**TOWN OF NEWBURGH  
PLANNING BOARD**

**PROJECT NAME:** MID VALLEY / STARBUCKS  
**PROJECT NO.:** 23-14  
**PROJECT LOCATION:** SECTION 75, BLOCK 1, LOT 13.1  
**REVIEW DATE:** 9 AUGUST 2023  
**MEETING DATE:** 17 AUGUST 2023  
**PROJECT REPRESENTATIVE:** BOHLER – STEVEN R WILSON/KIMBERLY HORN ENGINEERING & LANDSCAPE ARCHITECTURE

**Re: Response to Comments Summary  
Proposed Starbucks Store  
39 North Plank Road  
Section 75, Block 1, Lot 13.1**

SHEET TITLE:  
**SITE LAYOUT PLAN**  
SHEET NUMBER:  
**C-301**  
REVISION 2 - 08/02/2302

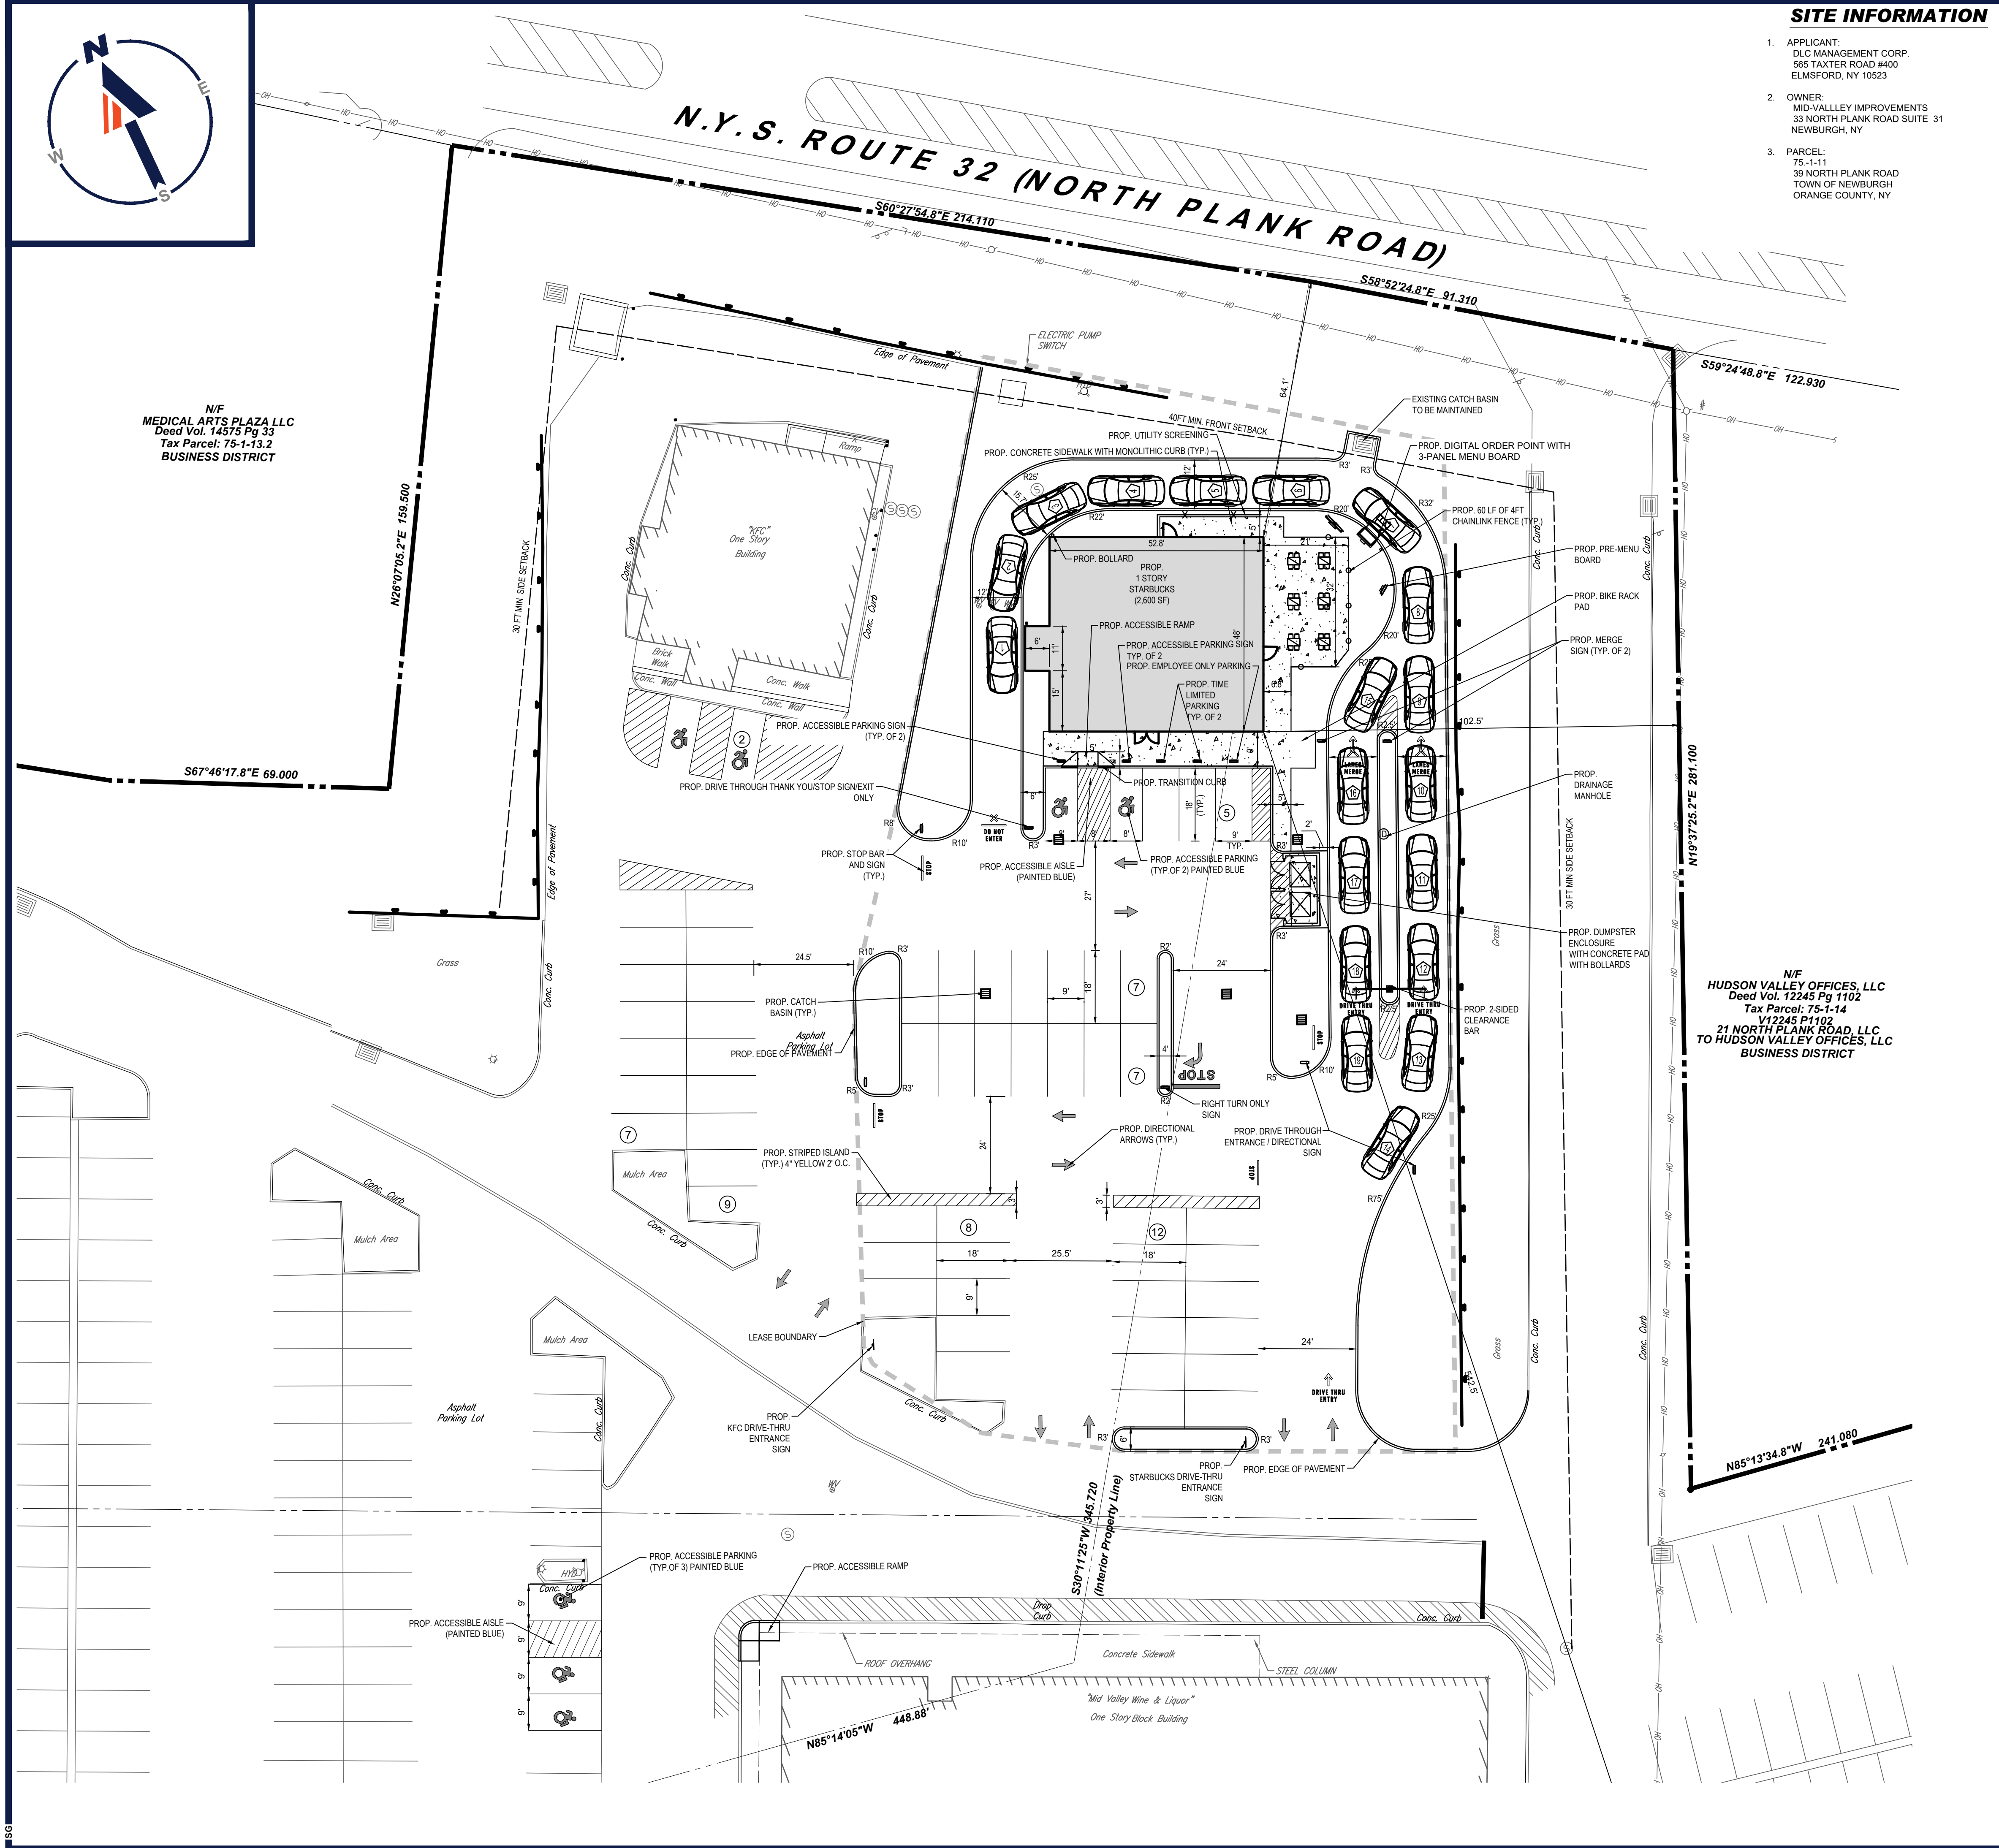
1. The proposed project results in a significant reduction of parking existing on the site. Approximately 60 parking spaces will be lost by the Site Plan. The project site is a "Unified Site Plan" with the entire Price Chopper/ Mid Valley Mall parcel. A parking calculation for the entire site must be prepared to identify adequate parking exists.

3. The queuing aisles for the drive-thru do not have an “escape” area. Subjects queuing into the drive-up window cannot leave the drive-up window area.

4. Garbage truck access looks reasonable; however, aesthetics should be considered since the dumpsters are located in front of the building.

5. The plan proposes two queue lanes that merge into one just before the menu board. We've seen dual lanes for ordering that merge for payment and food pick-up. Are the two lanes simply to add storage capacity?

*With the addition of the Starbucks, the total Gross Leasable Floor Area is 243,627 SF. Per Section 185-13 of the Town of Newburgh Zoning Code, Shopping Center in excess of 25,000 SF of Gross Leasable Floor Area (GLFA), parking will be provided at a ratio of 1 space per 225 SF of GLFA. This equates to 1,083 required parking spaces. The overall site, post-development, will provide 1,253 parking spaces – or 170 excess spaces. Refer to the enclosed Building/Parking Summary.*

*Based on experience with more than 600 store throughout New York, Starbucks does not consider lack of an “escape area” as an operational concern. The drive-thru entry is located in an isolated portion of the site into the site and supplemented with ample directional signage.*

*This is being reviewed and will be addressed as part of a subsequent submission. Design will include a dumpster enclosure to shield dumpsters from public view.*

*The two lanes are designed to provide additional storage capacity. A significant portion of Starbucks drive thru business is mobile to go ordering. Additional ordering capacity is not needed since a large portion of customers are entering the drive thru after already submitting their order.*

**EXTERIOR ELEVATIONS**

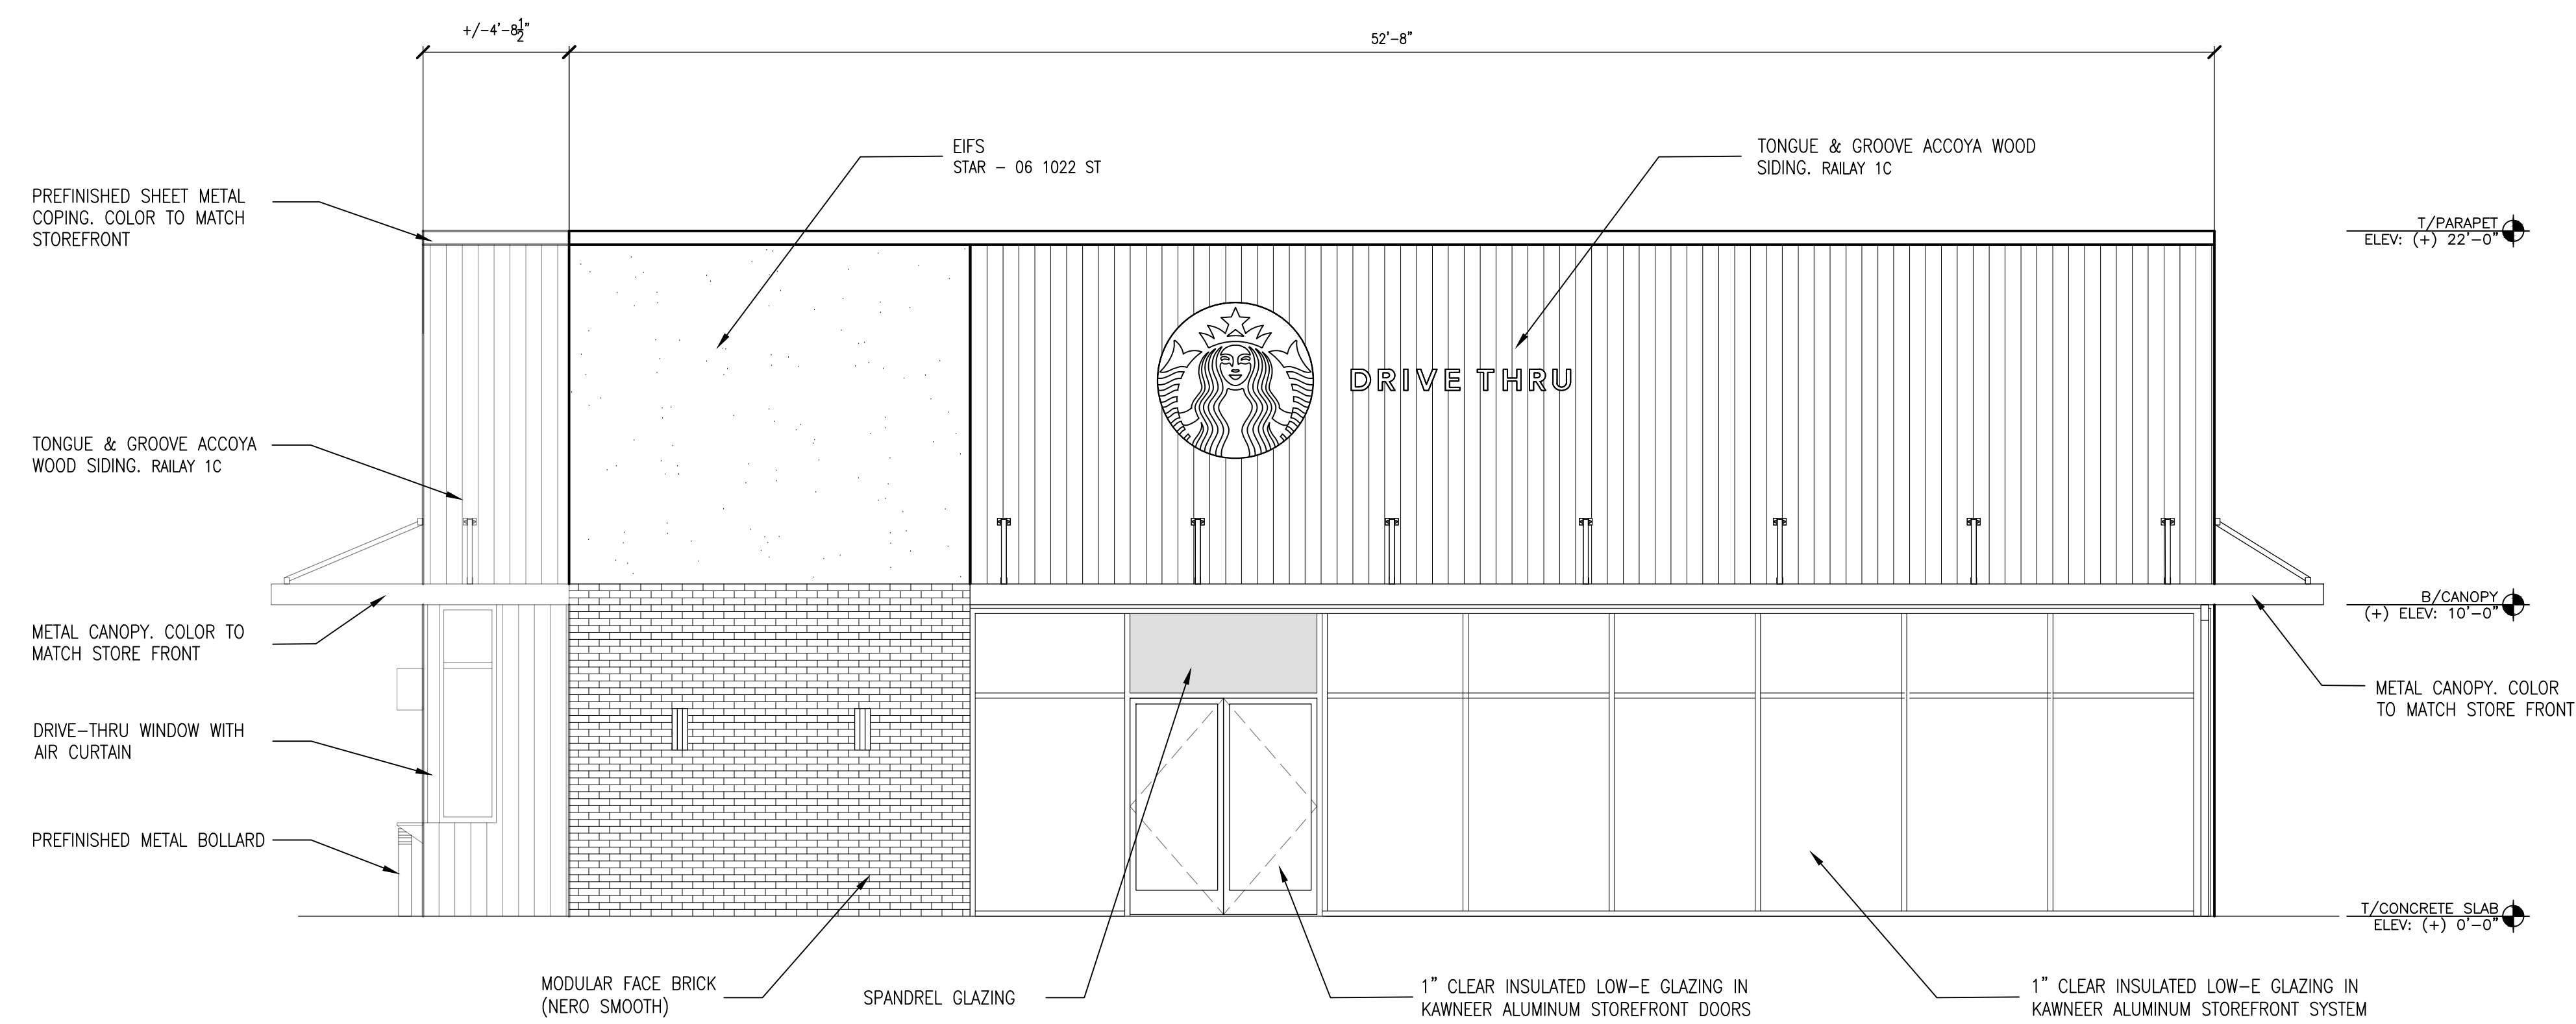
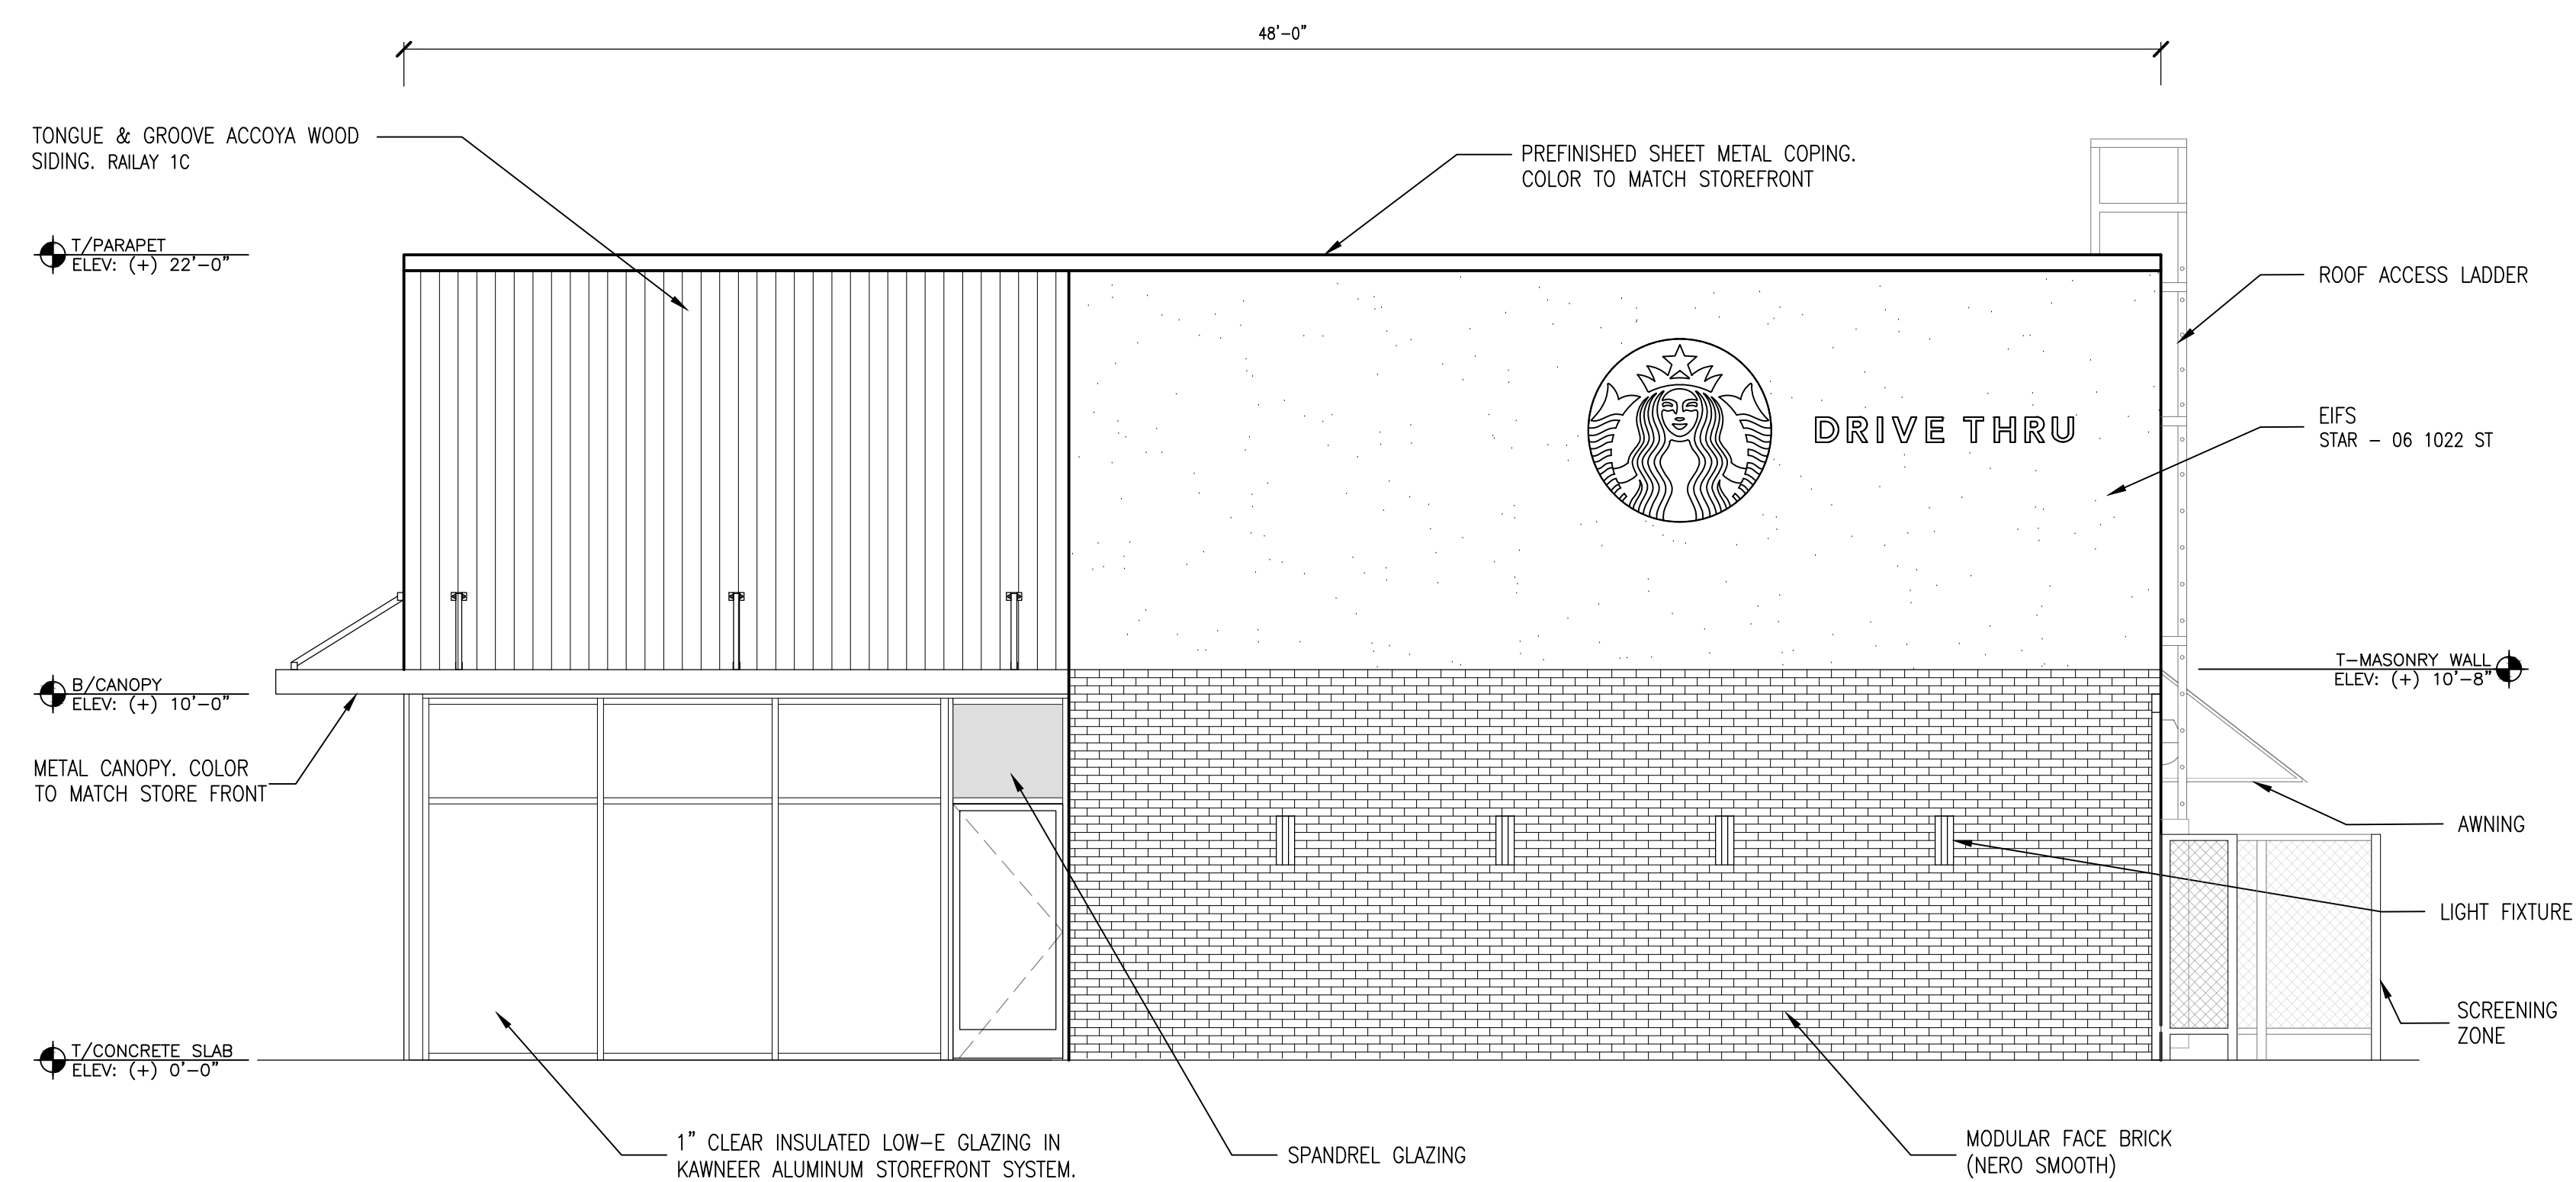
5. Any signage for the site should be depicted.

*The enclosed site plan and updated elevations identify proposed signage. All signage is consistent with bulk requirements.*
